Product Change Notification

1. ECR #: 26-62279-1
Notification #: 859

- ECUO - OPTICAL FIREFLY ASSEMBLY
- OTP - OTP

Visual differences between Senko and US Conec Ferrule

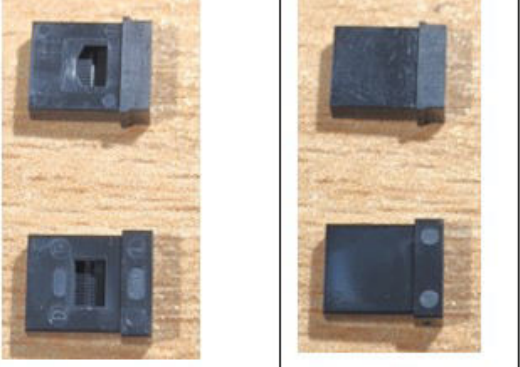
Replace the US Conec Elite ferrule with Senko low loss ferrule due to limited supply of US Conec low loss ferrule. Comparison testing showed the new Senko ferrules to perform equal to the US Conec ferrule. The new Senko ferrule meets the same testing performance as the US Conec ferrule. Interchangeability was tested and found to be acceptable.

Senko ferrule does not have the US Conec brand name marking. See pictures showing the differences between the ferrules visible to the Customer.

a. US Conec Senko	
b.	 Senko MPO-PLUS EZ-Way US Conec MTP
c.	 US Conec Elite ferrule Senko ferrule *Both inside US Conec housing
